Origination Form
Proposed Revisions to a Standard Plans Index

Originator:	Turley, Joshua	Index Number:	102-200
Date:	5/15/2025	Sheet Number(s):	All sheets
E-mail:	Joshua.Turley@dot.state.fl.us	Index Title:	TEMPORARY ACROW 300 SERIES DETOUR BRIDGE GENERAL NOTES AND DETAILS

PLAN - AB7 BEARINGS WITH EXPANSION BEARING SLIDING ASSEMBLY

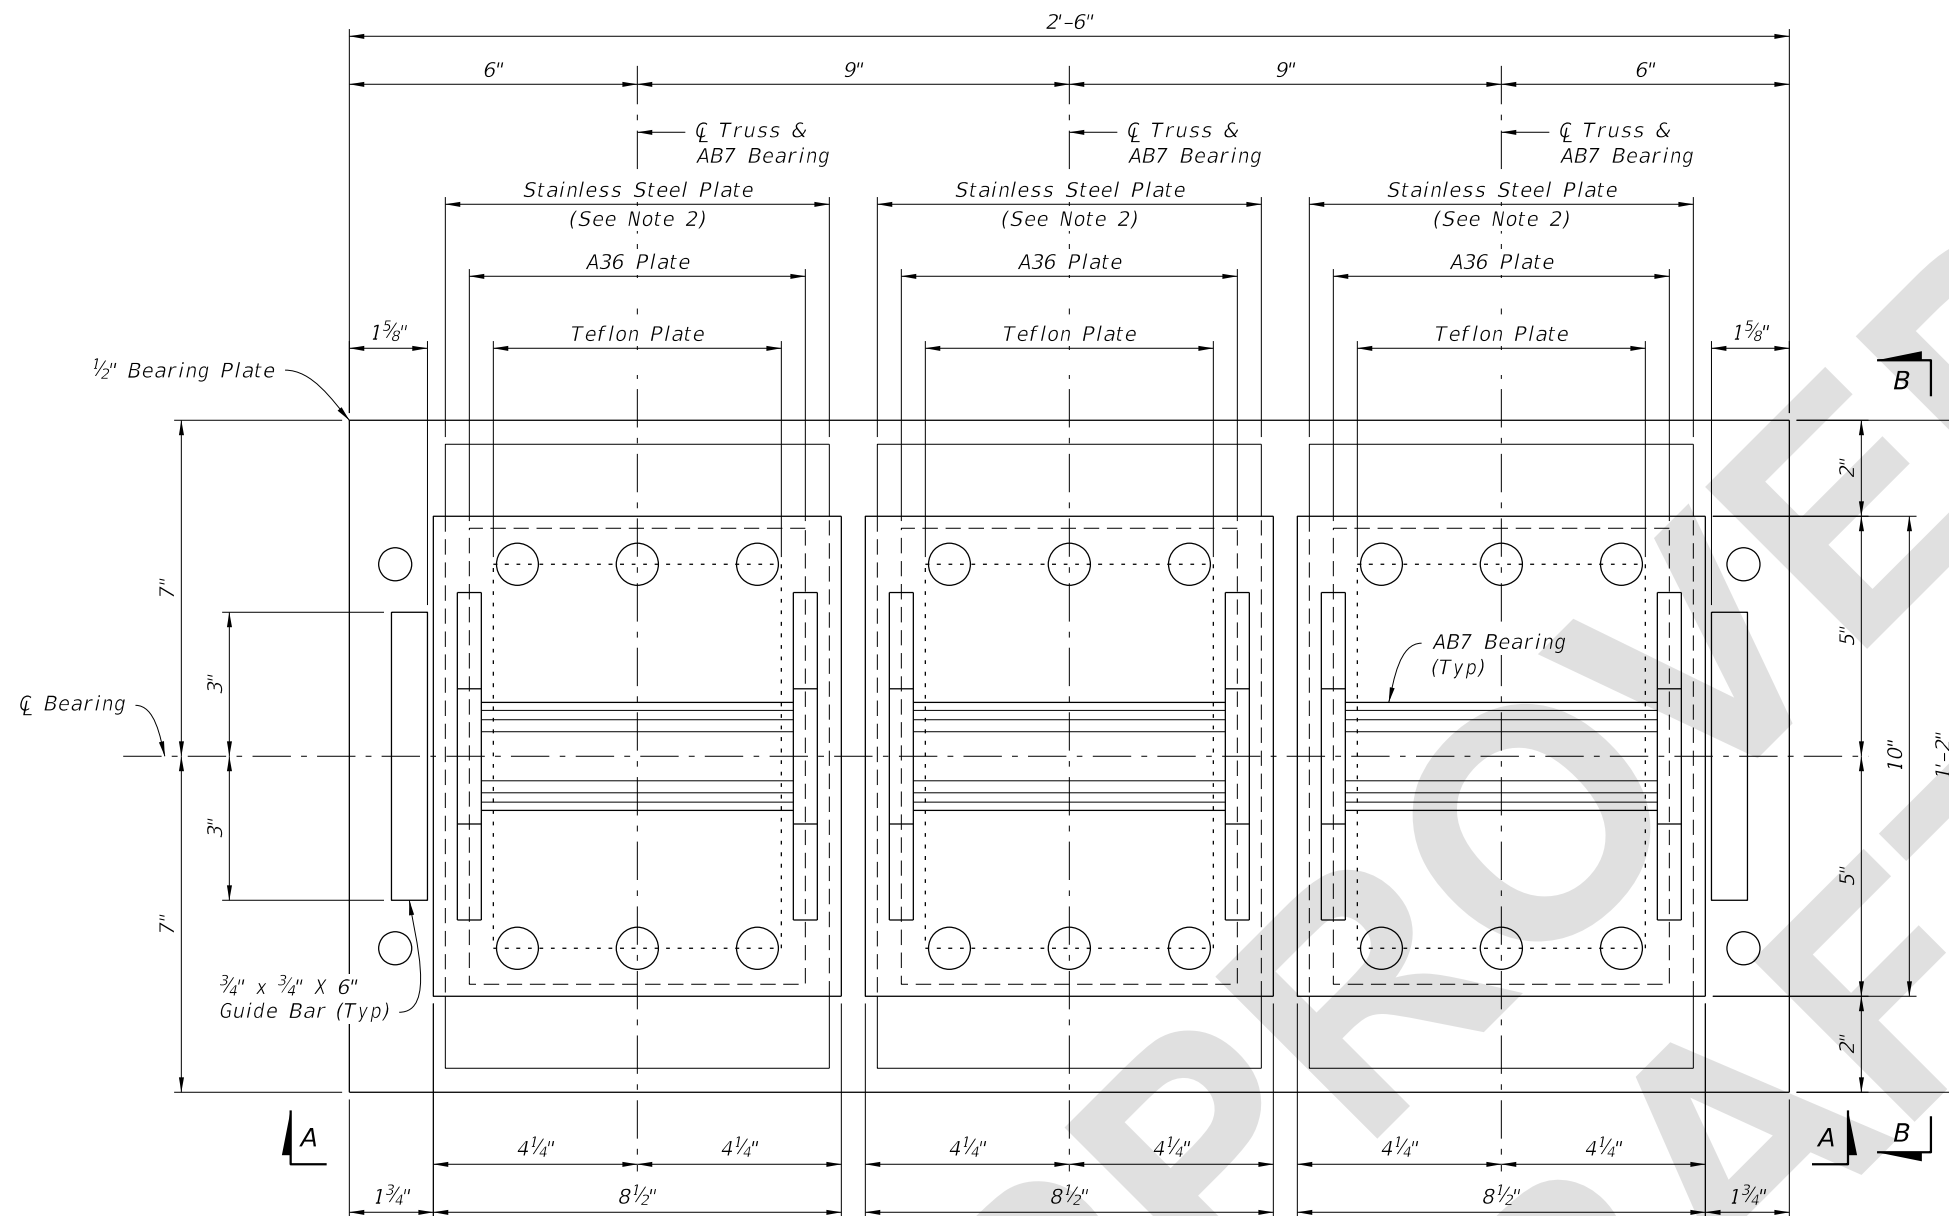
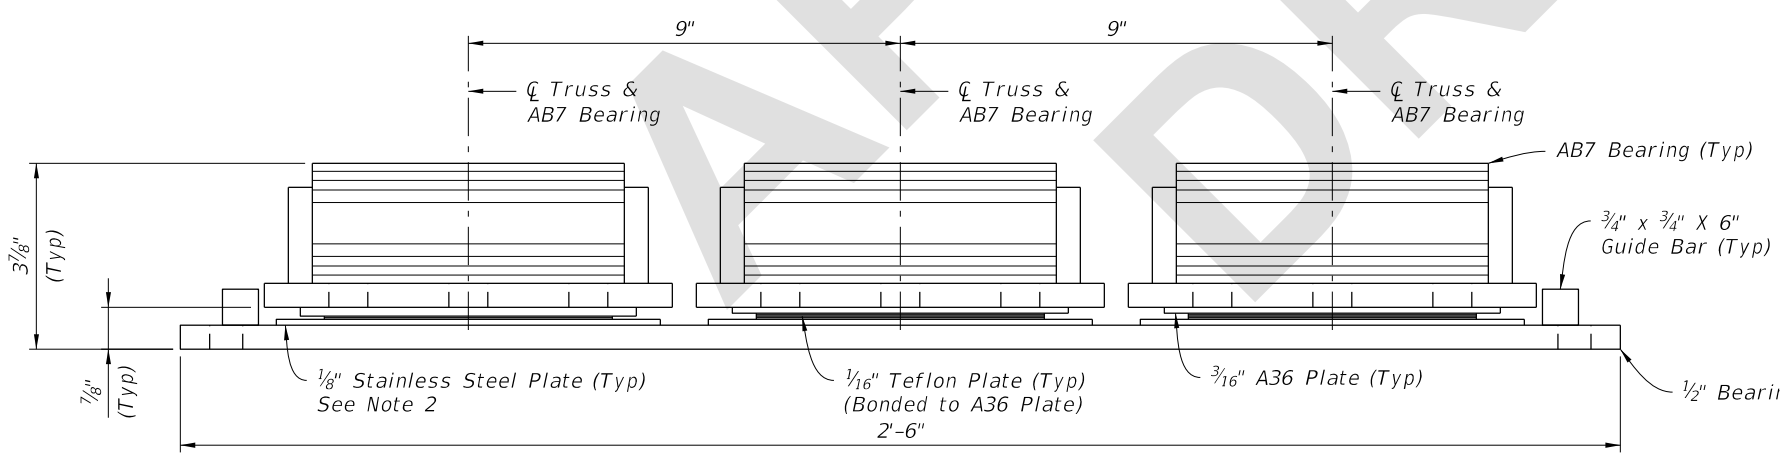
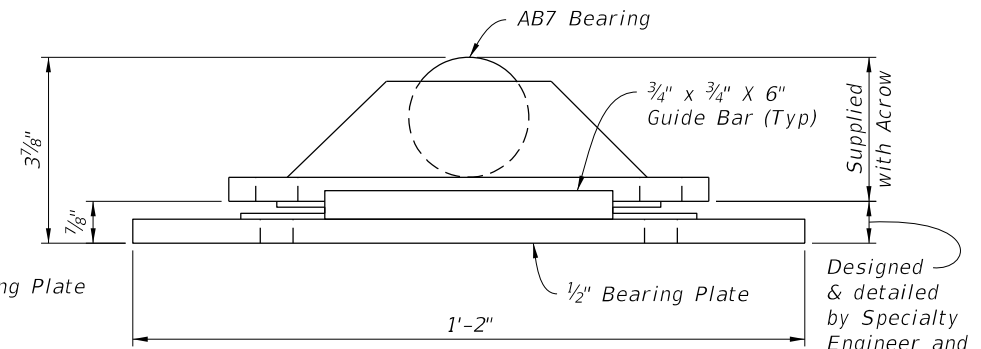
Sheet 3: We dont actually know the underside dimension for the bearings until final design so it is inappropriate to ball park the dimension.
 Sheet4: We are being more specific about what FDOT does and does not provide to the Contractor.
 Sheet 5: Deleted sheet and added information with expanded details for clarity on new Sheets 7 and 8.
 Sheet 7: Expanded details of the bearings add clarity.
 Sheet 8: Expanded details of the bearings add clarity.

**NEW SHEET 8: Details for End
Bent Bearings**

1. Expansion Bearing Sliding Assembly consists of Bearing Plate, Guide Bars, Stainless Steel Plates, Teflon Plates, and A36 Plates.
2. Clean and polish Stainless Steel Plates to provide a smooth sliding surface.

Designed & detailed by Specialty Engineer and supplied by Contractor
